SUBJECT: AMENDMENT NO. 110 TO FACILITY OPERATING LICENSE NO. DPR-43
(TAC NO. M88374)

KEWAUNEE NUCLEAR POWER PLANT

AMENDMENT TO FACILITY OPERATING LICENSE

Amendment No. 110
License No. DPR-43

FIGURE TS 3.10-2

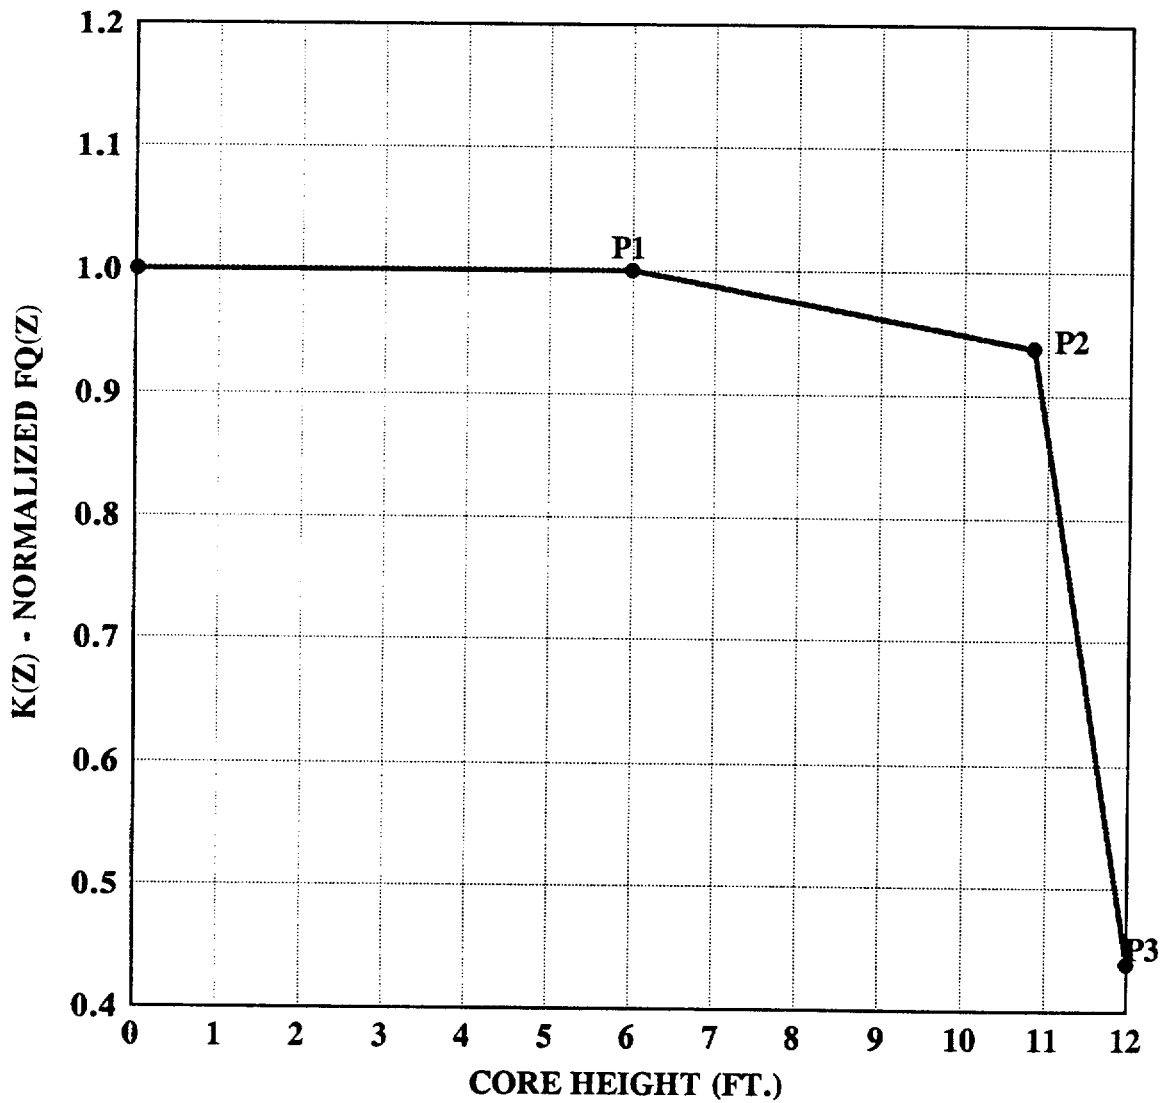
TS 3.10.b.1, 3.10.b.4, and Table TS 3.10-2 currently specify limits for the heat flux hot channel factor and the nuclear enthalpy rise hot channel factor; the heat flux hot channel factor under equilibrium conditions; and the hot channel factor normalized operating envelope, respectively. The current TS provide these hot channel factor limits for both Westinghouse Electric Corporation Fuel and Siemens Power Corporation Fuel.

The licensee's proposal eliminates the hot channel factors for Westinghouse Fuel from these TS as this type of fuel is no longer used at KNPP. The limits for Siemens fuel, the current fuel vendor, are retained and are not affected by the proposed change.

Since the proposed change is administrative in nature, and does not alter the intent or interpretation of the specifications, the staff finds it acceptable.
